CITY OF VAUGHAN

EXTRACT FROM COUNCIL MEETING MINUTES OF JUNE 24, 2014

**SITE DEVELOPMENT FILE DA.14.032
YORK CATHOLIC DISTRICT SCHOOL BOARD
WARD 1 - VICINITY OF MAJOR MACKENZIE DRIVE AND HUNTINGTON ROAD**

COMMITTEE OF THE WHOLE JUNE 17, 2014

Site Plan

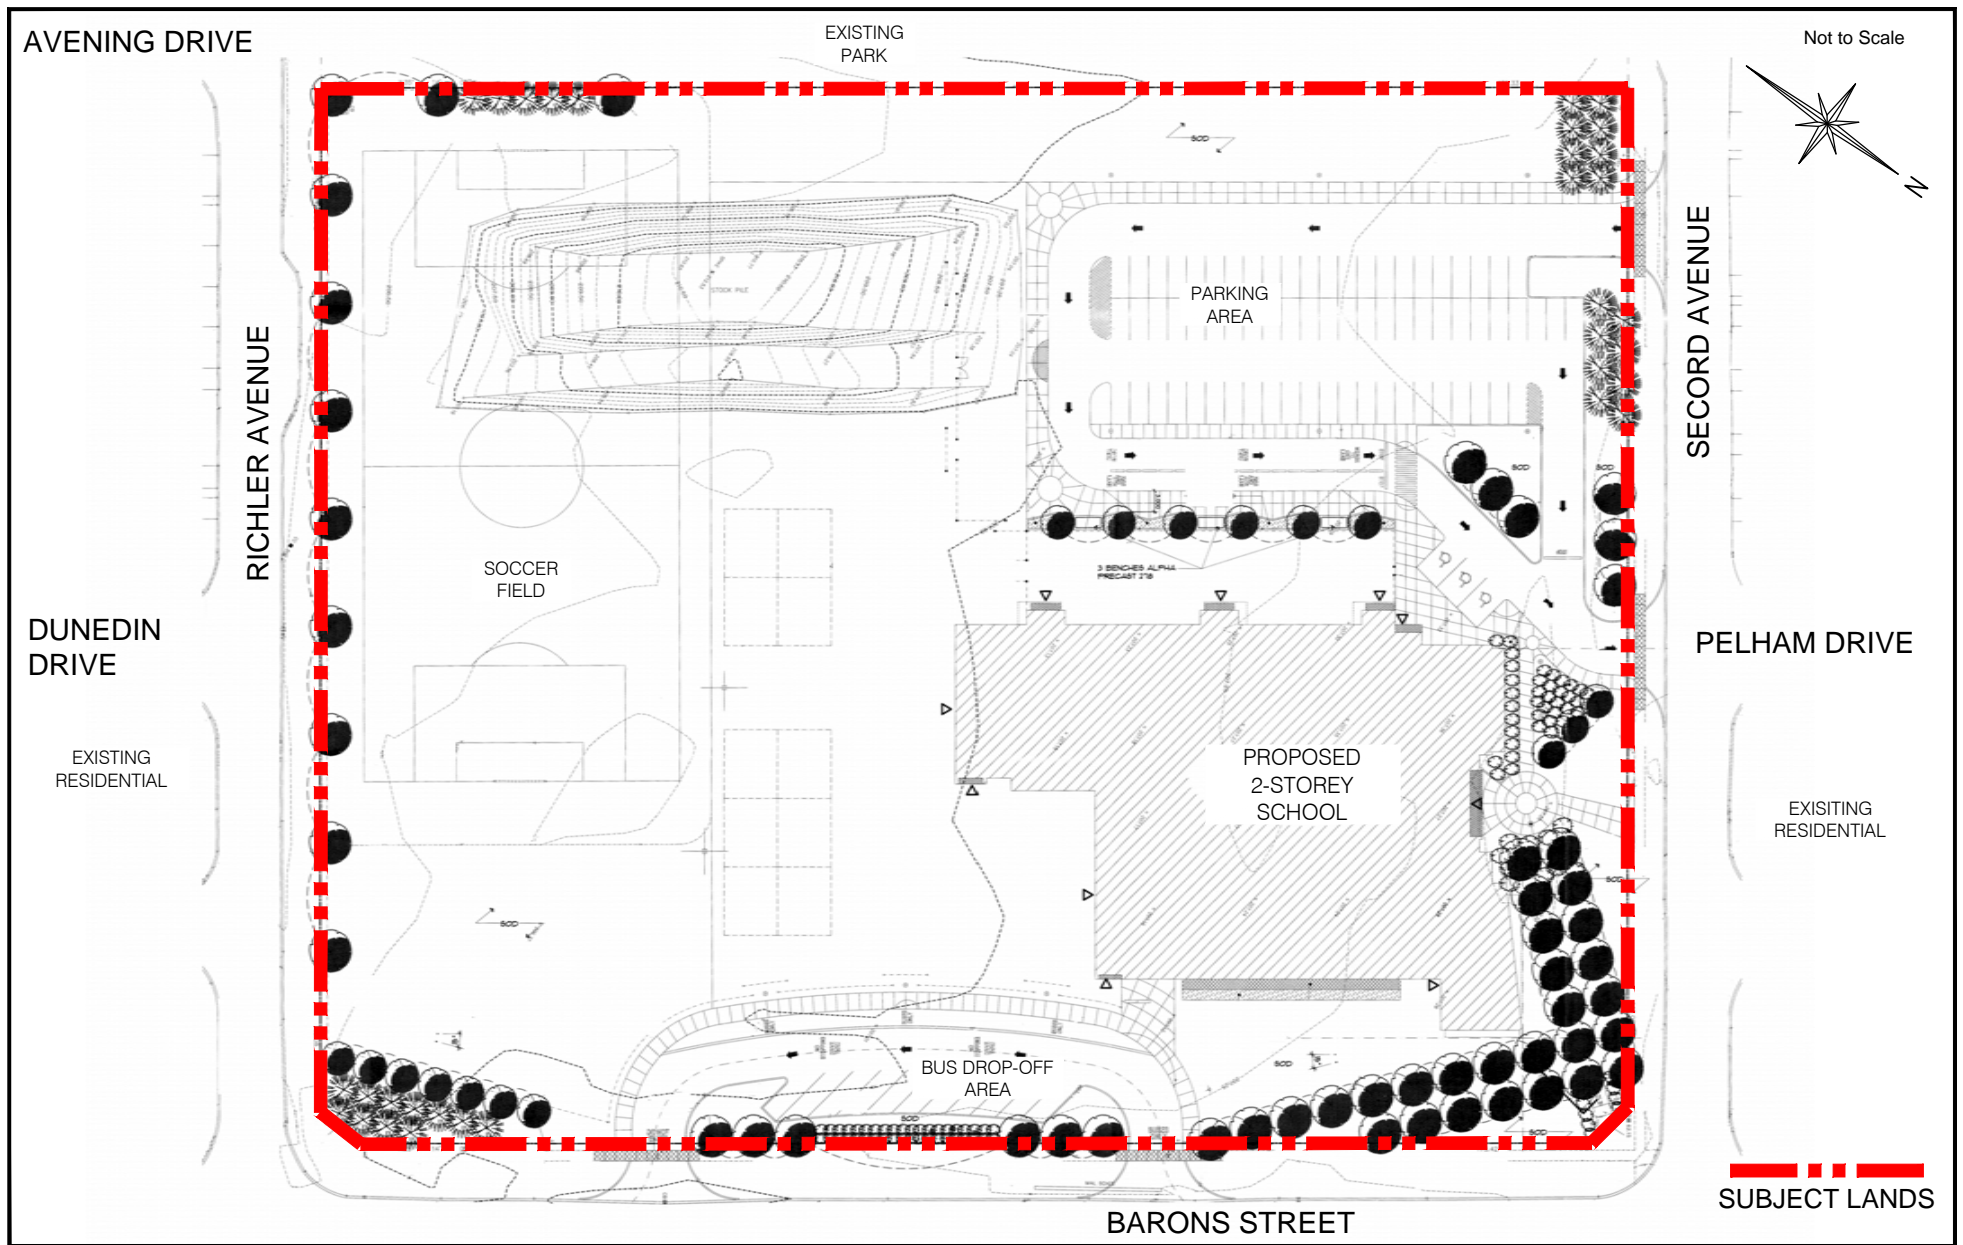
The two-storey, 6,960 m² elementary school as shown on Attachments #3 to #6 inclusive, is proposed on a lot with street frontage on three streets, being Secord Avenue to the north, Barons Street to the east and Richler Avenue to the south. The main building entrance is located on the Secord Avenue frontage. Vehicular access is provided on Secord Avenue and Baron's Street. A soccer field is proposed along the Richler Avenue frontage and a proposed neighbourhood park abuts the site to the north. The Baron's Street access leads to a circular driveway dedicated to school bus drop-off only, and also includes 11 visitor parking spaces. The main parking area contains 67 parking spaces and is located at the northwest portion of the site, accessed from Secord Avenue. Three barrier-free parking spaces and bike racks are also located in this area, as

shown on Attachment #3. Two play areas are proposed, with the main play area at the south end of the school and a fenced-in, kindergarten play area along the west elevation. Ten future portables are also proposed on the site, located between the soccer field and the main play area, as shown on Attachment #3.

The two-storey, 6,960 m² elementary school as shown on Attachments #3 to #6 inclusive, is proposed on a lot with street frontage on three streets, being Secord Avenue to the north, Barons Street to the east and Richler Avenue to the south. The main building entrance is located on the Secord Avenue frontage. Vehicular access is provided on Secord Avenue and Baron's Street. A soccer field is proposed along the Richler Avenue frontage and a proposed neighbourhood park abuts the site to the north. The Baron's Street access leads to a circular driveway dedicated to school bus drop-off only, and also includes 11 visitor parking spaces. The main parking area contains 67 parking spaces and is located at the northwest portion of the site, accessed from Secord Avenue. Three barrier-free parking spaces and bike racks are also located in this area, as shown on Attachment #3. Two play areas are proposed, with the main play area at the south end of the school and a fenced-in, kindergarten play area along the west elevation. Ten future

portables are also proposed on the site, located between the soccer field and the main play area, as shown on Attachment #3.

Landscape Plan

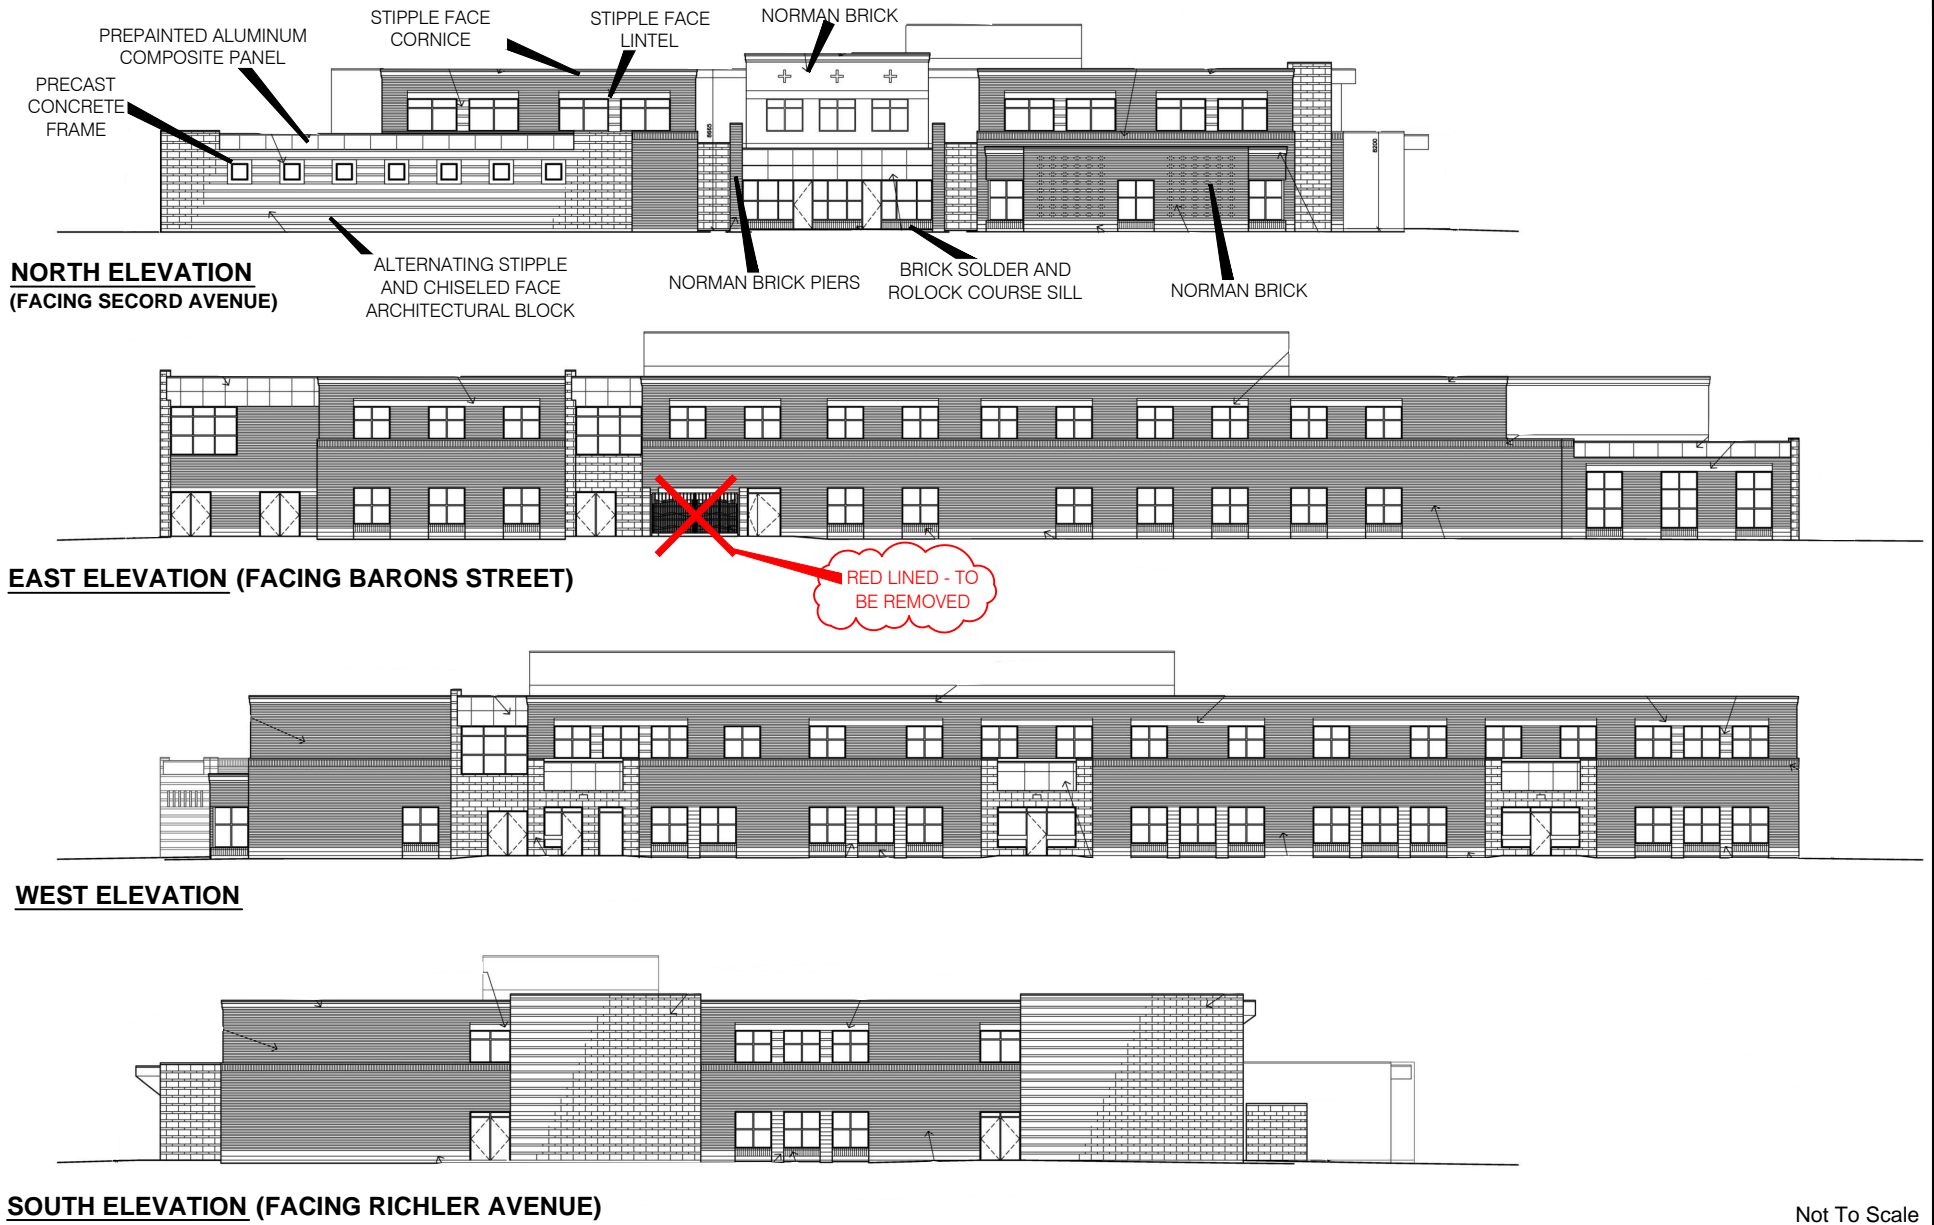
The reduced landscape strip along Barons Street applies only to the portion of the strip located between the two access points of the circular bus driveway as shown on Attachment #4. A 3 m width is sufficient to accommodate the planting.

The Planning Department has reviewed the landscape plan as shown on Attachment #4, and advises that the School Board should work to enhance the pedestrian circulation by connecting the main entrance to the intersection of Barons Street and Secord Avenue, and by addressing the pinch point created at the northwest corner of the building, adjacent to the barrier-free parking spaces. The landscape plan should also be amended to coordinate landscaping and access points to the adjacent park to the north.

The reduced landscape strip along Barons Street applies only to the portion of the strip located between the two access points of the circular bus driveway as shown on Attachment #4. A 3 m width is sufficient to accommodate the planting.

The Planning Department has reviewed the landscape plan as shown on Attachment #4, and advises that the School Board should work to enhance the pedestrian circulation by connecting the main entrance to the intersection of Barons Street and Secord Avenue, and by addressing the pinch point created at the northwest corner of the building, adjacent to the barrier-free parking spaces. The landscape plan should also be amended to coordinate landscaping and access points to the adjacent park to the north.

Building Elevations

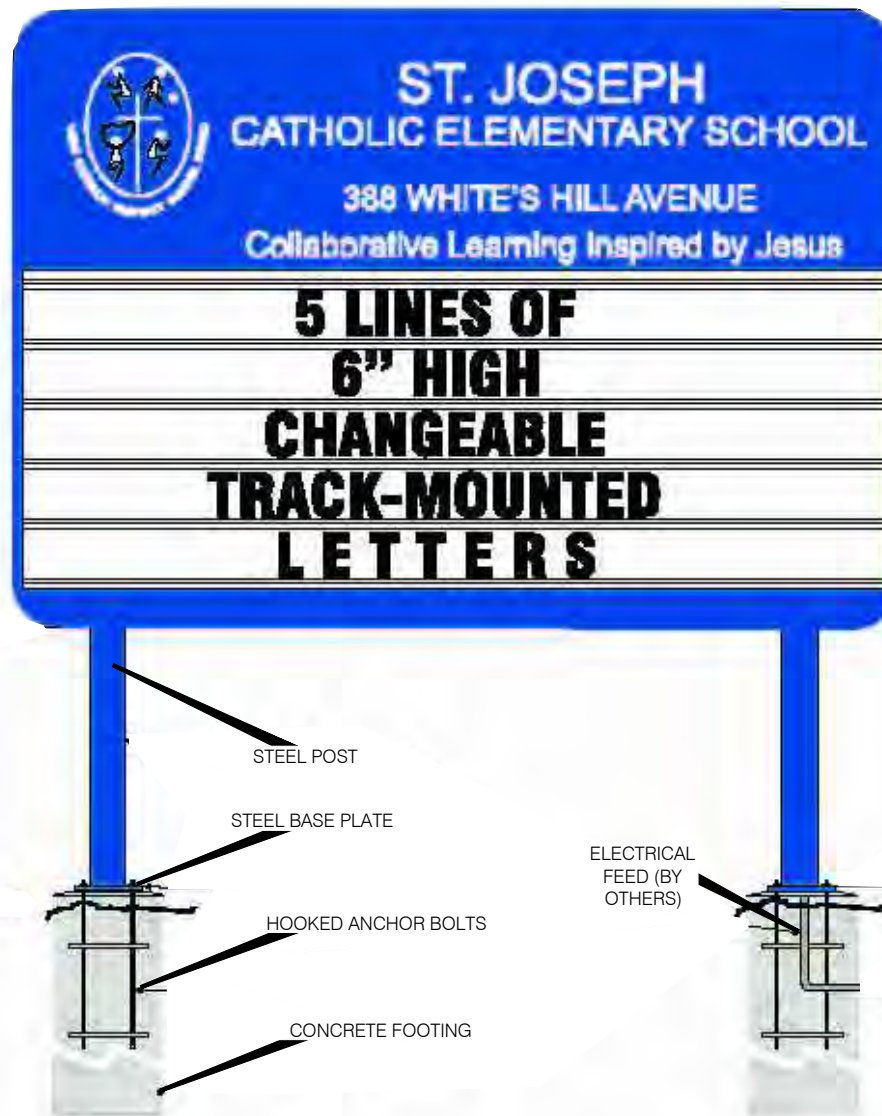
The Planning Department has reviewed the elevations as shown on Attachment #5, and requires upgrades to the elevations at the Secord Avenue and Barons Street intersection, as well as the blank walls along the south elevation (rear) in the form of additional fenestration and articulation. The subject lands are located within the Block 61 Community Plan area, and therefore, the proposed elevations are subject to the review and approval of the Block 61 Control Architect, John G. Williams Limited.

The Planning Department has reviewed the elevations as shown on Attachment #5, and requires upgrades to the elevations at the Secord Avenue and Barons Street intersection, as well as the blank walls along the south elevation (rear) in the form of additional fenestration and articulation. The subject lands are located within the Block 61 Community Plan area, and therefore, the proposed elevations are subject to the review and approval of the Block 61 Control Architect, John G. Williams Limited.
